KIA MOTORS

NUMBER
044 [Revised]

TECHNICAL SERVICE BULLETIN

ECM UPGRADE WITH TP SENSOR REPLACEMENT – MIL ON WITH DTC P2135 / P0638

PARTS INFORMATION

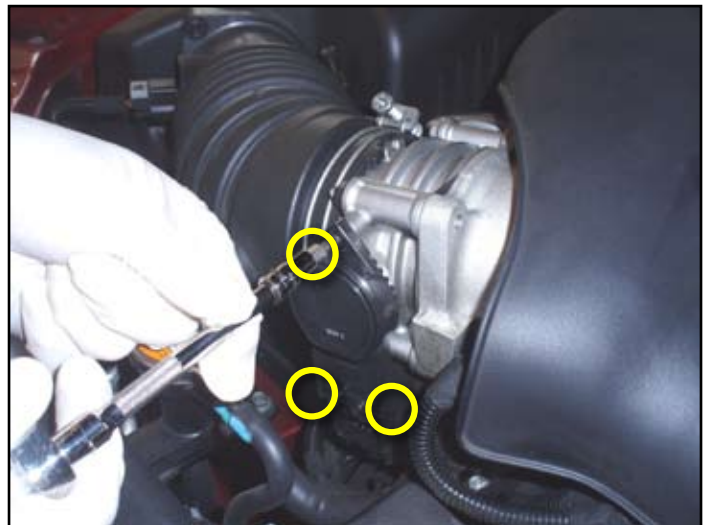
Part Name	Part Number		Part Kit
Throttle Position Sensor (TPS)	Optima/Rondo with 2.7L	35107 3E000FFF or 35107 3E100FFF	
	Sedona, Sorento and Amanti with 3.3L or 3.8L	35107 3C000FFF or 35107 3C100FFF

****Only supplied w/3C100FFF***

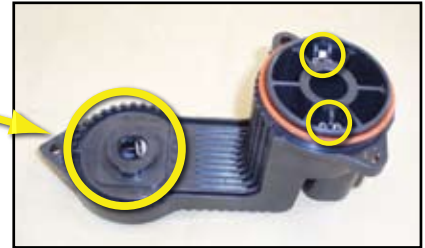
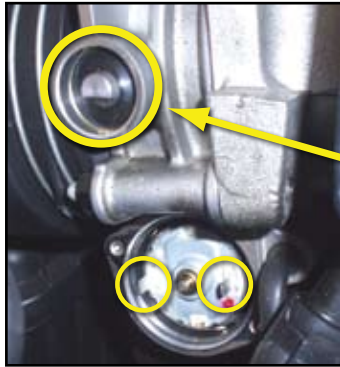
1. Open hood and remove the engine cover if necessary.
2. Disconnect the TP sensor electrical connector.

3. Remove the three (3) torx mounting screws (T-20).

4. Remove the TP sensor from the ETC actuator.

**The O-ring sometimes will stick to the housing during removal.
Be sure to remove if this occurs.**
